TT415: Sportster Rocker Cover Hardware Change

July 6, 2009

APPLIES TO	SYMPTOMS
2008 - 2009 Sportster Models	<ul style="list-style-type: none">• Part Availability, Installation or Fitment Updates• Literature Updates or Corrections

Figure 1. Washer and Screw

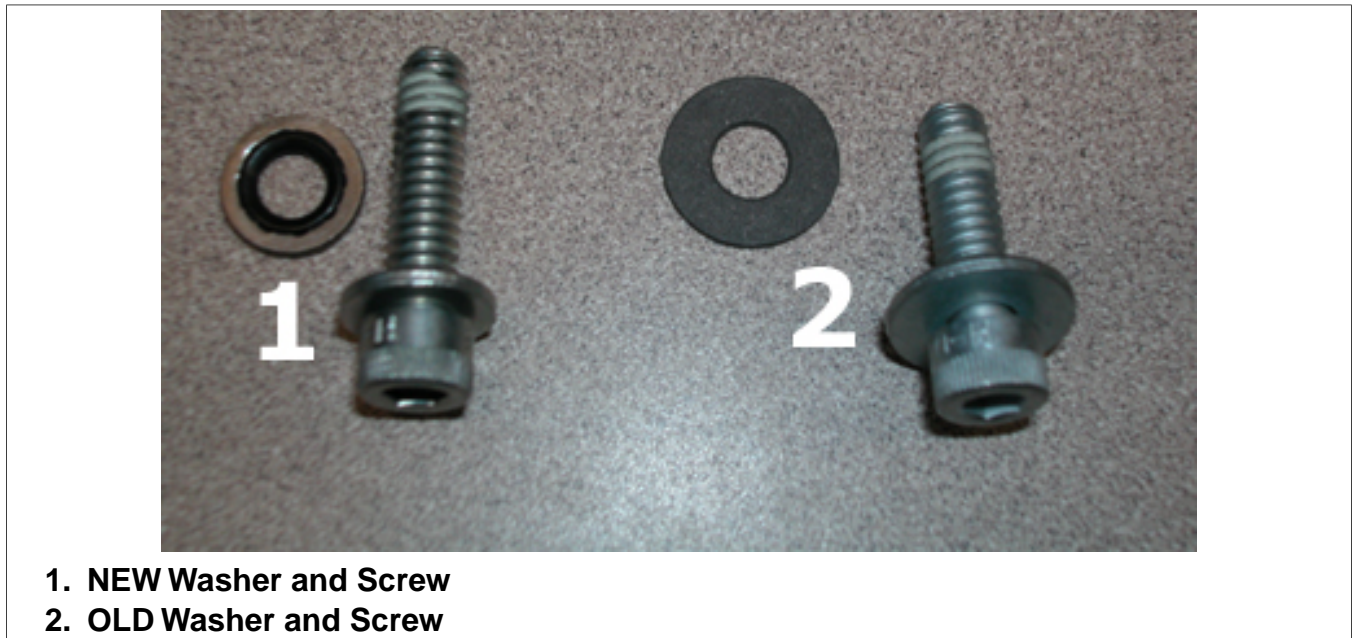
In May of 2008 there was a running change to the hardware for all XL rocker covers. This running change did affect the end of 2008 production and all 2009 XL models moving forward.

The change involves the fastener and washer for rocker cover shown in the image below. The washer has been improved for sealing, and the screw was changed to offer better thread engagement.

While these parts are listed correctly in the 2009 XL part catalog, they do retro-fit back to all 1986 and later XL models and 1984 and later Evolution engines.
